# Attachment 7 - Shellharbour Local Environmental Plan 2013

The applicant has submitted a Clause 4.6 Statement addressing the requested height exception. The applicant has also provided two height plane diagrams which demonstrate the extent of the exception, as provided at Figures 4 and 5 below and a Visual Impact Study as Attachment 3.1.

Figure 2: Height plane diagram north western corner

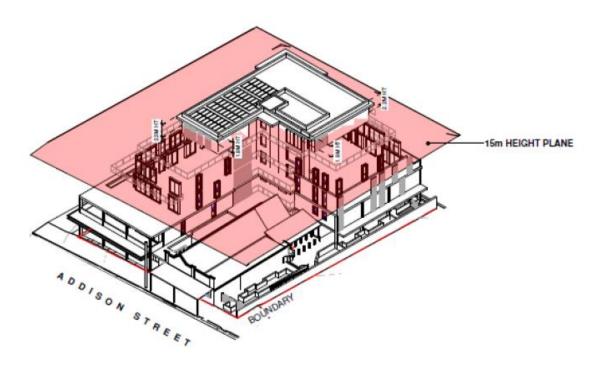
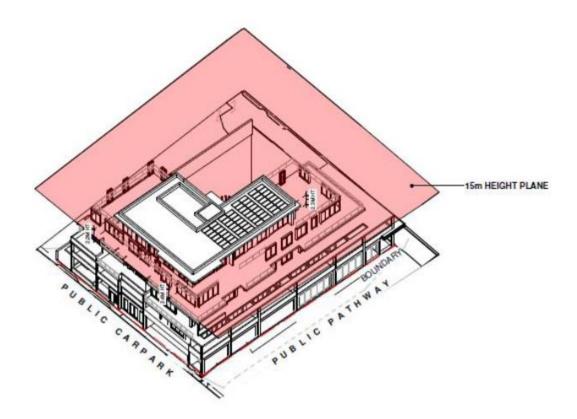
The Height of Buildings Map identified a maximum building height of 15m for the subject site. The proposed development has a maximum proposed height of 18m to the lift overrun and therefore exceeds the maximum permitted by 20% (3m). See consideration at Clause 4.6 below.

The Visual Impact Study that was submitted during the assessment process illustrates that the component of the building form that exceeds the maximum building height will not be visible within the immediate public domain along Addison Street. Whilst the Study illustrates that the uppermost level will be visible from a wider streetscape context, the height exceedance beyond the development standard will not be discernible due to the changes in topography on Addison Street.

<u>Council Comment:</u> The environmental planning ground provided in the Applicant's statement are supported in this instance.

The application has adequately demonstrated that the proposed height of the development will not result in adverse amenity impacts on surrounding properties.

The proposal is considered to be consistent with the objectives of Clause 4.3

Figure 7: Line of sight between No. 29 and 35 Addison Street, public laneway and proposed development

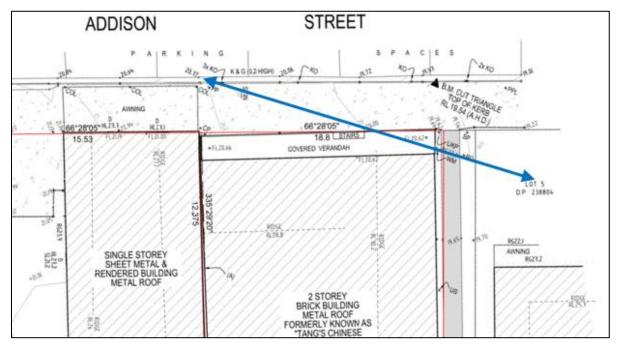
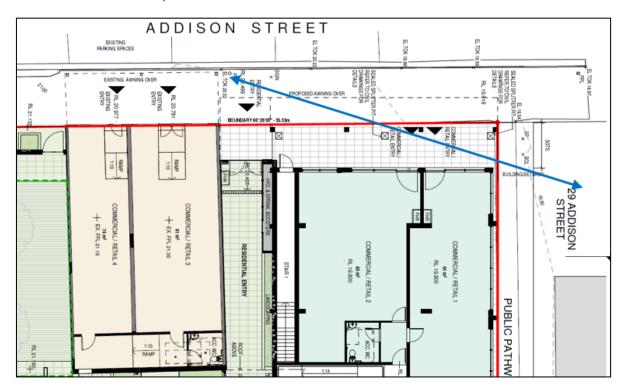
Clause 5.10(4) requires consideration be given to the potential impacts of development upon heritage items including associated fabric, seatings and views. During the assessment process the front setback of the development was increased to maintain the existing line of sight connecting the heritage buildings at No. 29 and 35 Addison Street and the between No. 35 Addison Street and the public laneway (illustrated in Figures 6 and 7).

The northern and eastern setbacks of the ground floor and first floor align with the building form of the existing commercial building at No. 31-33 Addison Street. Additionally the proposed commercial and residential entrance verandah aligns with the verandah of the Allen's Store. This is considered appropriate from both a topography and heritage perspective and it continues the building rhythm of Addison Street at a pedestrian scale.

The setbacks from the development to both heritage items increase with the height of the building and the articulation of elements (particularly balconies) which provides a sense of space and results in less bulk and scale in close proximity to the heritage items. In this regard, strict numerical compliance with the SDCP 2013 (front setbacks) and ADG setbacks (side setbacks) would not result in a good urban outcome, as has been noted by the DRP. The distribution of building mass away from the heritage items and towards the rear property boundary (adjoining a Council own public car park) is considered an appropriate design response in this instance.
